ISSUES & REVISIONS		DATE:
FOR PERMIT		AUGUST 9, 2023
FOR CONSTRUCTION		MARCH 25, 2024
CONSTRUCTION BULLETIN #1		MAY 15, 2024
CONSTRUCTION BULLETIN #2		NOVEMBER 15, 2024
LIGHTING SPECIFICATIONS REQUEST		FEBRUARY 13, 2025
CONSTRUCTION BULLETIN #3		FEBRUARY 20, 2025
OWNER APPROVED PLANS		FEBRUARY 28, 2025

PROJECT TITLE:	
LOPA COMPOUND DEVELOPMENT	
Lopa Farm Marilaque Highway Sitio Mayagay, Brgy. Sampaloc, Tanay Rizal

SHEET CONTENTS:	
HOUSE 5 FLOOR PLAN AND ROOF PLAN

SCALE:	AS SHOWN	SHEET NO : A-100
DRAWN BY:	ADI, JJC, NEC, MMT, BCA	
CHECKED BY:	MCD	
DATE:	02/20/2025	
REVISED:

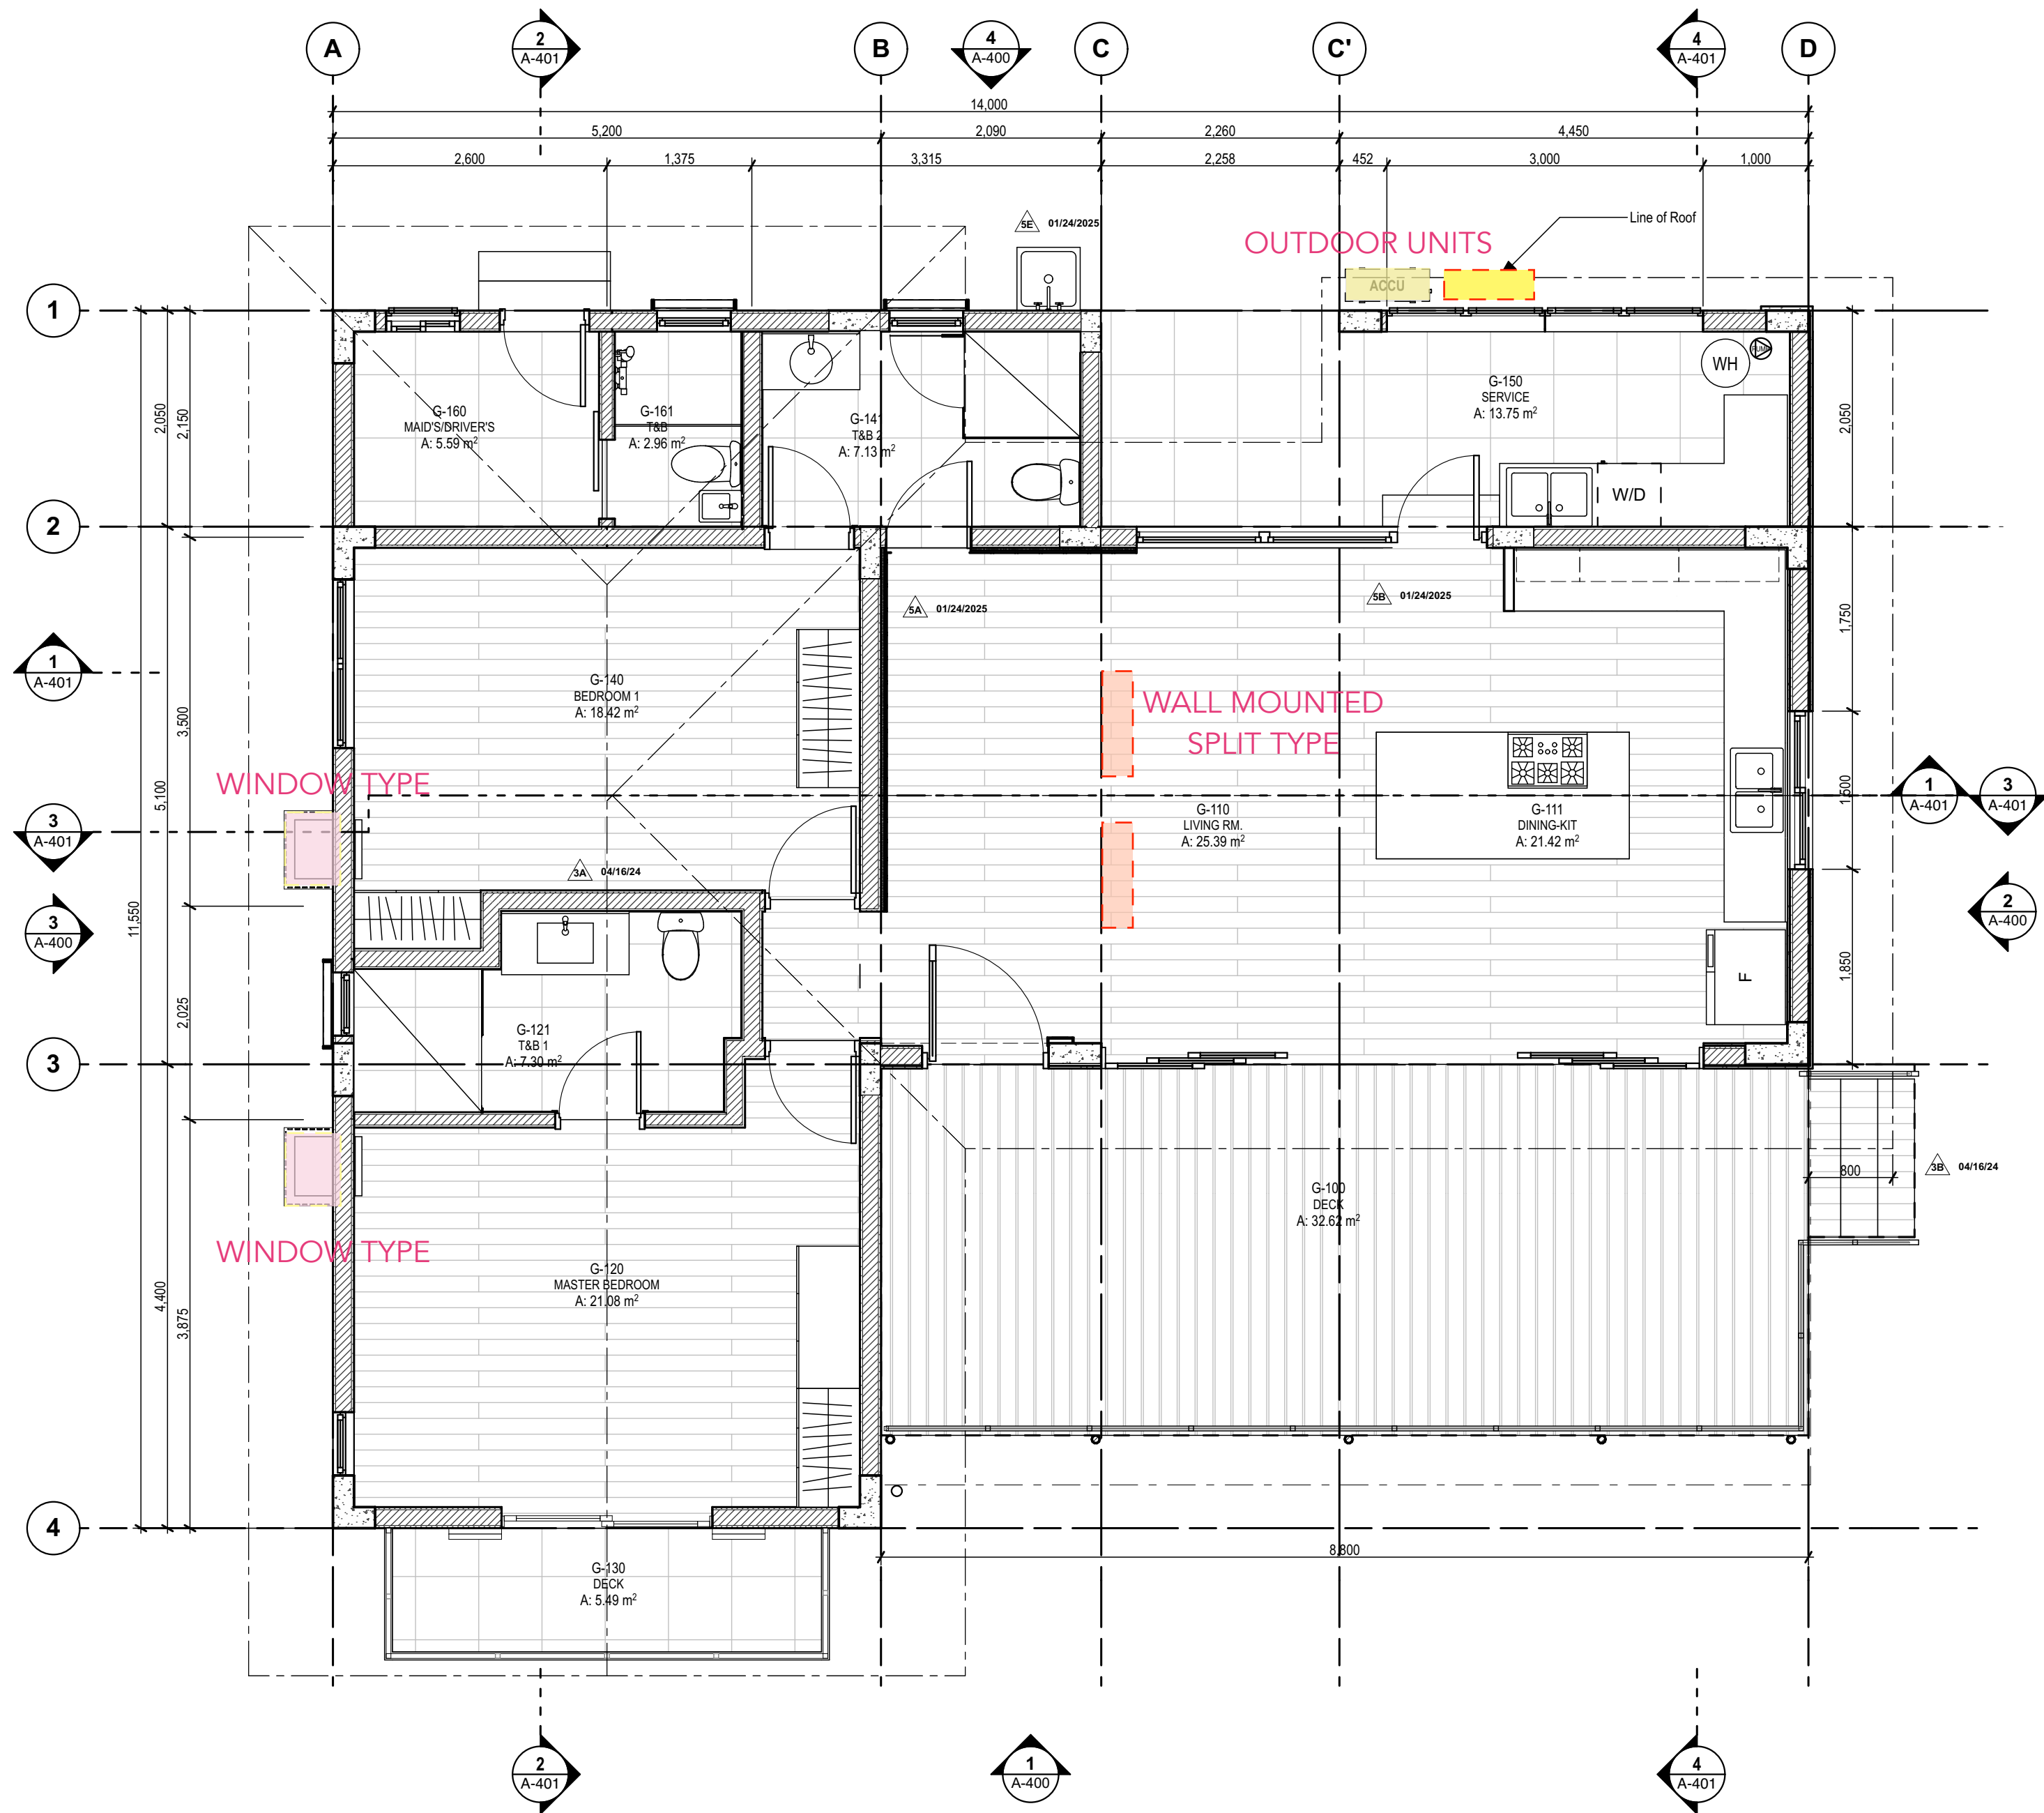
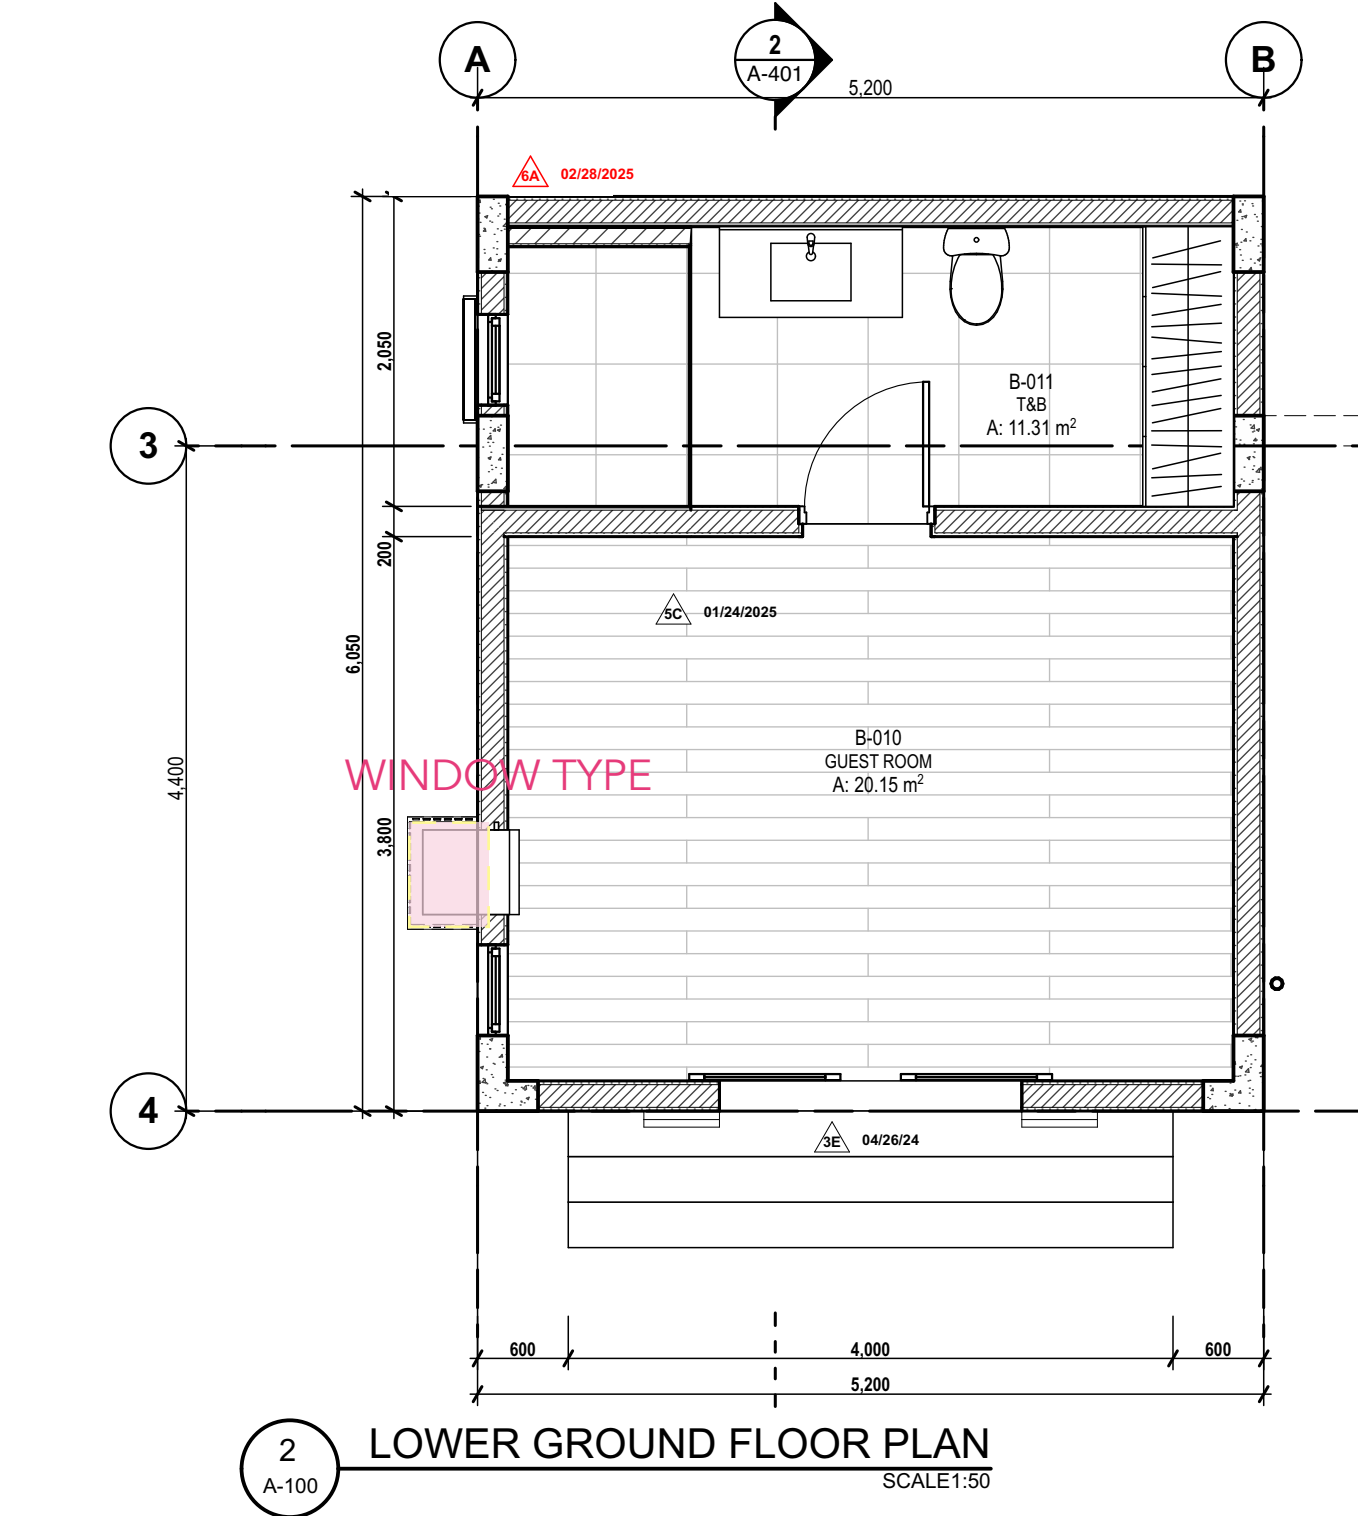
REVISION NOTES	
NOVEMBER 15, 2024	4A - REFLECTED FLOOR ELEVATION/DEPRESSION ON FLOOR FINISH PLAN
	4B - VERIFIED ELEVATIONS
01/24/2025	5A - ADDITION OF CABINET AT BEDROOM
	5B - CHANGED THE MATERIAL OF THE DOOR FROM ALUMINUM TO SOLID WOOD
	5C - LAVATORY HAS BEEN REPLACED FROM DOUBLE TO SINGULAR LAVATORY; TOILET HAS BEEN ADJUSTED TO GIVE WAY FOR CABINET. CABINET HAS BEEN ADDED
	5D - ADDITION OF GUTTER AT GLASS TRELLIS
	5E - ADDITION OF SLOP SINK
02/28/2025	6A - ADDITION OF DOUBLE WALL AT BASEMENT TOILET FOR PIPING
